Approved for access by the Solid Waste Department.  
All containers must be made accessible for pick up  
between the hours of 5AM and 8PM.

Reviewer: Herman Gallegos

NEW APARTMENTS  
NM BOYS AND GIRLS RANCHES  
6401 COORS BOULEVARD, N.W.  
ALBUQUERQUE, NEW MEXICO

## SITE DEVELOPMENT PLAN

SDP-1

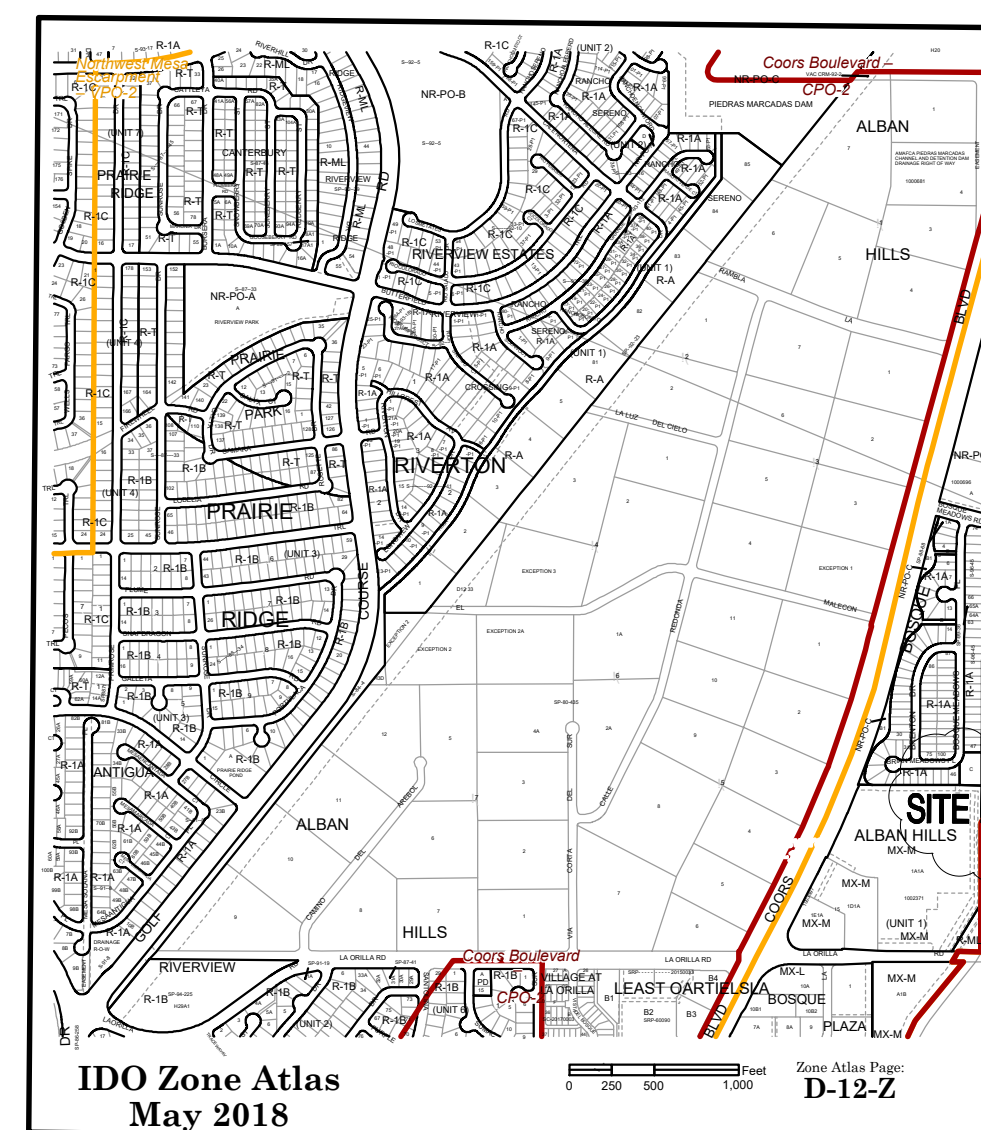
**\*\*Swanson enclosure\*\***
